Access Compliance Report Public Rights-of-Way (Curb Ramps)

Main Street: CHANTILLY_LN		Cross Street: PLEASANTON_LN		Location:	SE
ADA ID: RPRK211020153756	Ramp Type: Type 4 - Parallel	Initial Pass/Fail: Fail	Overall Compliance: No	Severity Score:	15
Codes/Mitigation Info/Possible Solution			Field Measurements/Component Compliance

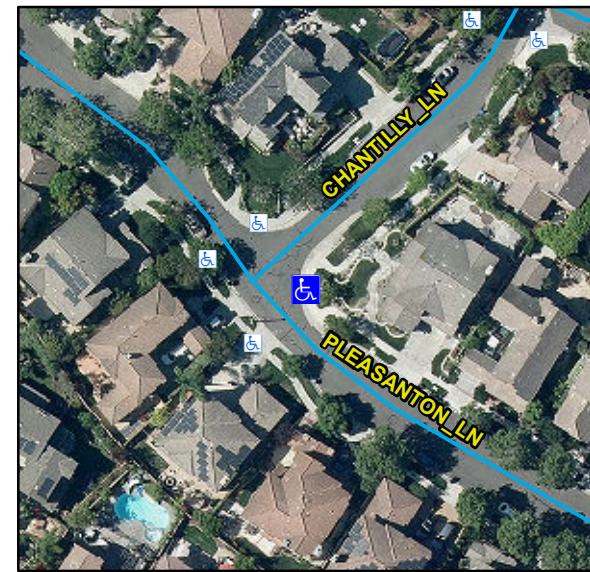
Compliance	Description	Data	Compliance	Description	Data
N/A	Ramp Length LT (in)	92	N/A	Ramp Length RT (in)	95
Yes	Ramp Width LT (in)	54	Yes	Ramp Width RT (in)	53
Yes	Ramp Run Slope LT (%)	5.3	No	Ramp Run Slope RT (%)	8.4
Yes	Ramp Cross Slope LT (%)	0.2	Yes	Ramp Cross Slope RT (%)	0.4
N/A	Landing Present	N/A	N/A	DWS Provided	N/A
N/A	Landing Length (in)	N/A	N/A	DWS Contrast	N/A
N/A	Landing Width (in)	N/A	N/A	DWS Length (in)	N/A
N/A	Landing Run Slope (%)	N/A	N/A	DWS Full Width	N/A
N/A	Landing Cross Slope (%)	N/A		DWS Offset Type	N/A
N/A	Landing Movement Obstructed?	N/A	N/A	DWS Offset Left (in)	N/A
	Landing Movement Type	N/A	N/A	DWS Offset Right (in)	N/A
N/A	Landing Shared	N/A			
N/A	Clear Space	Yes			
N/A	Clear Space To Crosswalk (in)	N/A			
N/A	Marked Crosswalk 1	No	N/A	Marked Crosswalk 2	No
	Crossing 1 Direction	N		Crossing 2 Direction	W
	Marked Crosswalk 1 Width (in)	N/A		Marked Crosswalk 2 Width (in)	N/A

Remove & Replace Curb Ramp With Two New Directional Ramps or Equivalent.
